NUMBER: 09-014-04

New Oil Filter Splash Guard For 3.7L Engine

2005 (WK) Grand Cherokee

Fig. 1 3.7L OIL FILTER SPLASH GUARD

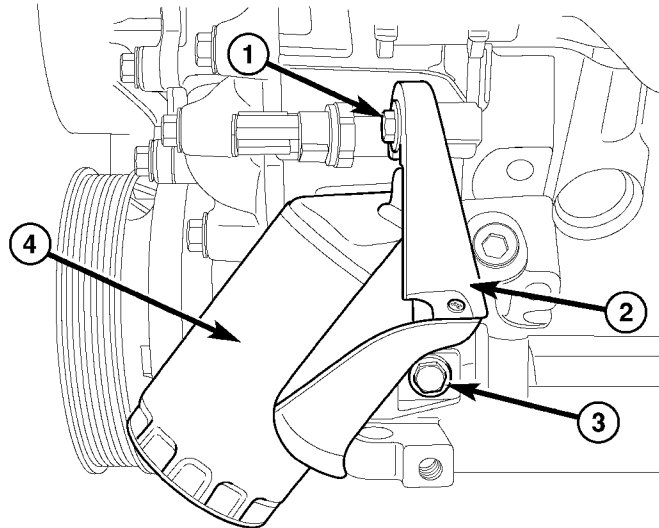
A number of early built vehicles equipped with a 3.7L engine may have been built without an additional oil filter splash guard to improve the control of engine oil when the oil filter is removed. The new oil filter splash guard is mounted directly to the engine block and is in addition to the plastic oil drain trough that is attached to the vehicle chassis.

1. Stop Engine. Raise vehicle on a suitable lift.
2. Hand start the splash guard top attaching bolt (6 mm) (Fig. 1).
3. Attach (hook) the end of the oil filter splash guard onto the top attaching bolt (6 mm).
4. Rotate the bottom of the splash guard towards the engine block. Hand start the splash guard bottom attaching bolt (10 mm).
5. Tighten the top 6 mm bolt to 12 Nm (105 in. lbs.)
6. Tighten the bottom 10 mm bolt to 55 Nm (41 ft. lbs.).
7. Lower vehicle.
